1.I. Viewpack

12. Karen Moss **06-1227** 17 Meadow lane Roof top solar 41-406.1 ACK Smart

ROOFTOP Solar Array
6.5 kW DC, 7.6 kW AC

2. 78 Wauwinet Rd, LLC **06-1065** 78 Wauwinet Road New dwelling 14-18 Emeritus

SOUTH EAST ELEVATION

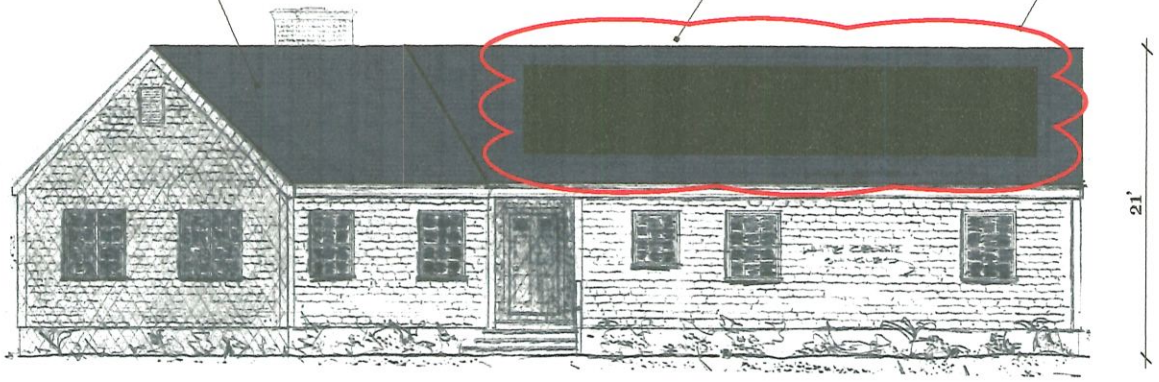
Voting: Pohl, Coombs, Camp, Oliver, Welch
Alternates:
Recused:
Documentation: Architectural elevation plans, site plan, photos, correspondence, and manufacturer spec sheet.
Representing: Tim Carruthers, ACK Smart
Public:
Concerns (7:09): **Carruthers** – Presented project; summarized letter from owners at 18 Meadow Lane; circa 1982; black on black. There is a code that sets the array must be set back from the edge of the roof twice its height; that has to do with heavy winds. The shed is too small and no room for a ground array; there is a precedent for arrays on the front.
Camp – It's on a cul de sac but the array on the front and would be right in your face; she didn't view this.
Oliver – Agrees with Ms. Camp. It would help if it covered the whole roof. Would prefer it not be on the front; would like some mitigation efforts. It could go on the shed.
Coombs – Agrees with concerns about it being on the front; doesn't know how buy the cul de sac is.

Welch – Agrees. A view is in order. Appreciates the include of the photos. For this to be successful, there would have to be some screening, not right on the street. A ground array is an option. He would like to view this.
Pohl – Scrub Juniper planted randomly would mitigate the visibility. Appreciates the black roof and being a 1-story house.
Motion: **Motion to View and Hold for revisions. (Welch)**
Roll-call Vote: Carried 5-0//Oliver, Coombs, Camp, Welch, and Pohl-aye Certificate #
